Docket Item # 9
BAR CASE #2010-0284

BAR Meeting
October 20, 2010

ISSUE: Alterations (Window Replacement)

LOCATION: 333 Green Street

Figure 7. Window Specifications

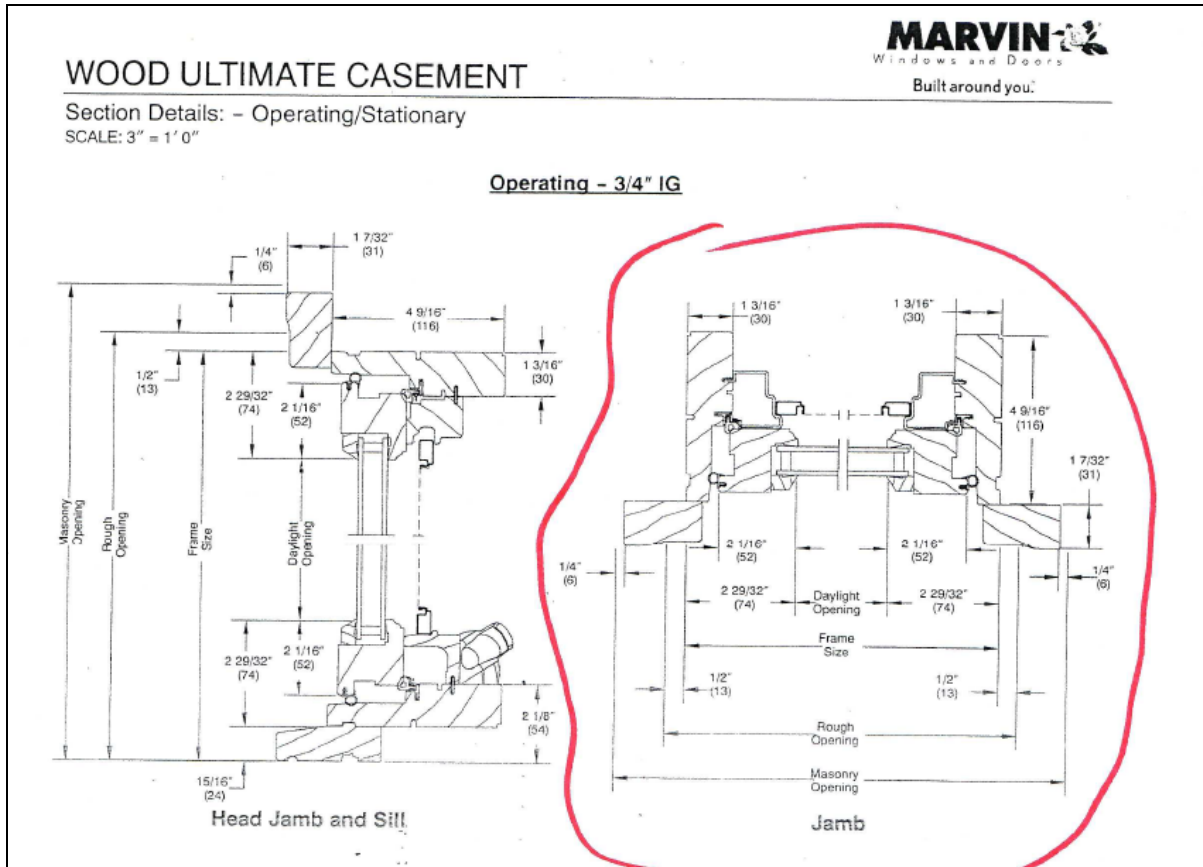
1. The proposed wood casement windows be installed with multi-light, simulated-divided light insulated glass windows with permanently fixed muntins on the interior and exterior, with spacer bars between the glass that are a non-reflective, medium value color;
2. Muntins must be paintable and have a putty glaze profile on the exterior;
3. The applicant must submit complete window manufacturer specification sheets and a contractor order form to BAR staff for final approval with the building permit application.

Since the existing windows are not original to the first period of construction, Staff supports their replacement and commends the applicant's desire to restore the window heights on the south elevation by lowering the sills to their original location. Staff also finds the use of double glazed replacement windows to be appropriate, as double-glazed windows were commonly available when this house was constructed in the mid-20th century. However, the proposed Window Policy of the Board suggests that the architectural design of original windows should be maintained when they are replaced.

Therefore, Staff supports the change to casement windows in this instance but recommends that they be modified to include simulated-divided lights with permanently fixed muntins in a pattern which replicates the original double hung windows. Since the Board does generally not dictate exterior paint color on previously painted surfaces, Staff does not object to the "Safari Brown" color. Staff believes this will substantially soften the difference between the windows in the original house and those on the addition, as the architect proposes. Staff has no objection to replacement of the existing plastic bubble skylights with the less visible and higher quality flat glass skylights.

STAFF RECOMMENDATION: Staff recommends approval of the application, with the conditions that:
